ADDENDUM 940-220-105 Issue 1, April 1972

RADIO ENGINEERING

MOBILE RADIO

ENGINEERING AND IMPLEMENTATION METHOD SYSTEM FOR 150-MEGAHERTZ BELLBOY®

Fig. 5—Primary Service Area Coverage Within Buildings—150-MHz BELLBOY

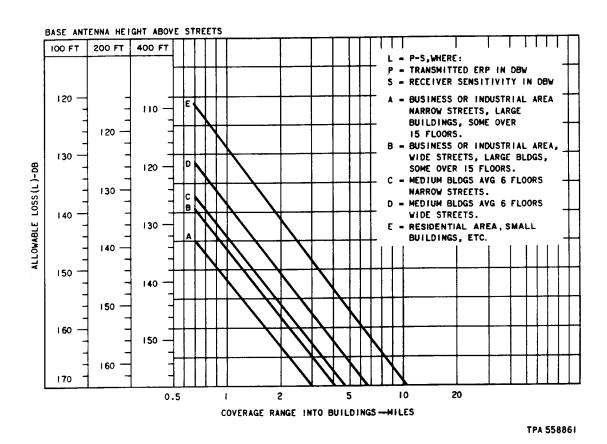
1.002 This addendum is issued to revise the information in and to change the title of

Fig. 5.
